Project 222630.00
10 April 2024
R.006.Rev0
ECR

Geotechnical Comment - Response to Design Queries

Proposed Stormwater Infrastructure

215 Badgerys Creek Road, Bradfield NSW

Figure 1: Extract from the 50% design plans showing proposed RSIC layout

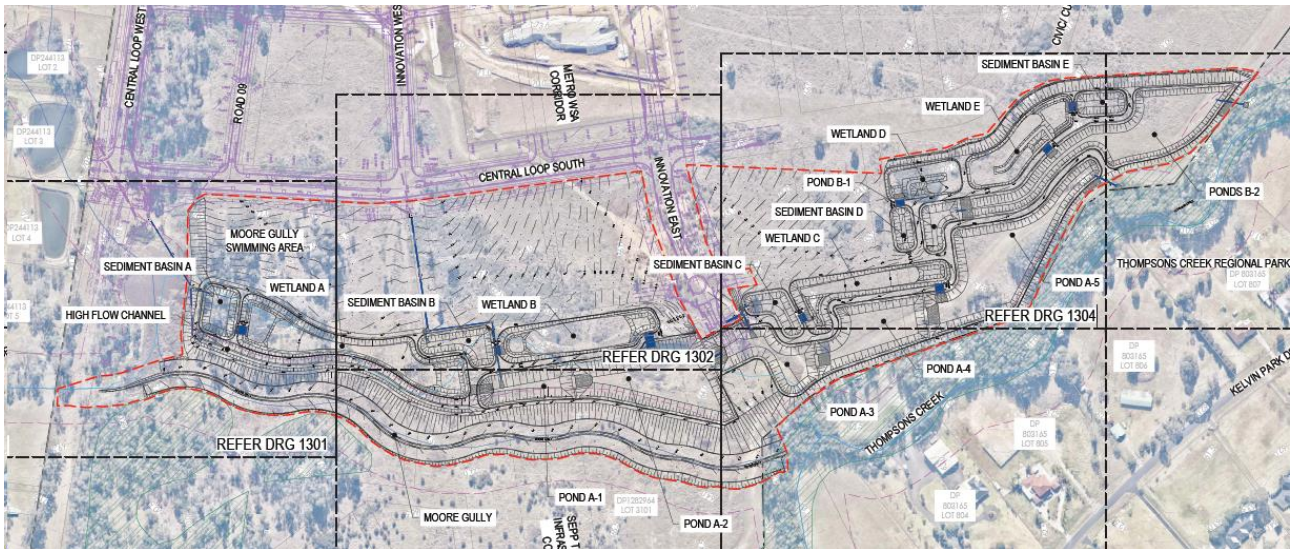
G7: Geotechnical advice required re: the basin embankment construction e.g. clay core between the basins.

G14: The report suggested clay liner or impermeable plastic liner to prevent localised raising of the groundwater levels. However, the report also suggested the area consist of clay with low permeability, is the existing clay material a natural liner? Or should we adopt impermeable plastic liner?

G15: The base of the basins need to be above the groundwater table, however the water level fluctuates. Should we use the highest levels in Table 1 to set the minimum basin base levels?

A zoned embankment, (ie an embankment that is not homogeneous in composition such as having a clay core or a clay surface to minimise water infiltration whilst the remainder of the embankment is formed from other materials) would typically be used where suitable clayey material is scarce. However, the complexity of the basin and wetlands layout will make it very difficult to construct using zoned embankments.

Homogenous embankments will be relatively straight forward to construct however the geotechnical investigation has indicated that the available cut/fill material comprises intermediate and high plasticity clay with a high dispersion potential. High plasticity clay will shrink and crack when dried creating unwanted water pathways. High dispersion potential indicates that the material will disperse easily, even in standing water, leading to high erosion rates and murky water. Therefore, the site clays are not suitable for direct use in embankment construction without stabilisation using lime or gypsum which will reduce the plasticity and dispersibility, thus making them suitable for reuse. Based on the above, consideration should be given to the three options presented below:

- **Option 1 – Stabilisation of the whole embankment.** The whole embankment would be constructed homogeneously using stabilised clay fill. This has the benefit of being straight forward to construct but has the downside of requiring a large volume of stabilised material.

- **Option 2 – Stabilisation of the outer layer of the embankments.** Only the outer layer would be stabilised. The treated clay blanket thickness should be at least 1m (measured perpendicular to the face of the batter slope). The inner portion of the embankment could comprise untreated site won clays. This option has the benefit of requiring less stabilised material and the downside of being harder to construct.

The use of a liner (stabilised clay or artificial) is recommended however this should be considered together with the response to previous query (G7). Any of the three options adopted should also be considered to act as a suitable, low-permeability, non-dispersive liner. The natural material is not suitable without stabilisation due to the dispersibility and shrink-swell potential.

The groundwater levels are determined by the surface water levels in Moore Gully and Thompsons Creek. The Moore Gully surface levels fall from RL67 in the west to RL 64 in the east where Moore Gully discharges into Thompsons Creek. Further east, the levels are determined by Thompsons Creek which falls to RL 59 near the eastern boundary of the site. The measured groundwater levels are all within a metre of the nearest creek surface water levels.

The use of the highest recorded groundwater levels presented in Table 1 for design may not be appropriate as they are isolated measurements of groundwater and have likely not captured maximum or minimum fluctuations. Notwithstanding, an increase of the shallow groundwater levels would result in (or be a result of) flooding of the areas surrounding the creeks.

Figures 2 and 3: Filter diaphragm sections for seepage and piping control around outlet pipe (Fell et al, 2005)

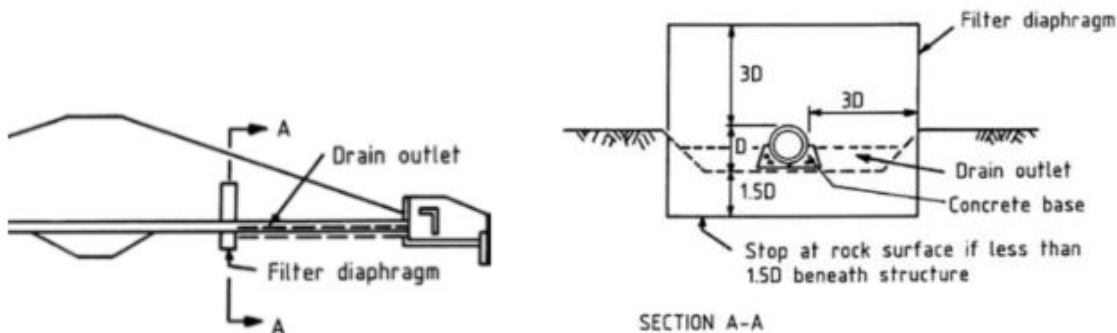
G33: There will outlet pipes through the embankments to convey water to the basins and creeks, please provide recommendation on the required treatment along the pipelines.

Pipes within the embankment are not recommended due to the increased risk of piping failure. A recommended design alternative is pipes installed under the foundation with risers on each end. If pipes within the embankment are adopted, the following should be incorporated into the design to reduce the risk of piping around the discharge pipes:

- Concrete encasement of the pipe to facilitate compaction of the clay surrounding the pipe. The sides of the encasement should be sloped not steeper than 1H:8V to facilitate compaction of fill around the pipe;
- Careful placement and compaction of clay material around the pipe. The clay fill should be placed slightly wet of optimum (1 – 2% wet) and not allowed to dry and crack prior to placement of additional embankment fill;
- Use of a filter diaphragm. The filter diaphragm would comprise a vertical "curtain" of sandy gravel material wrapped in a non-woven geofabric which connects to a drain outlet parallel to the pipe which drains into the outlet headwall; (refer Figures 2 and 3)
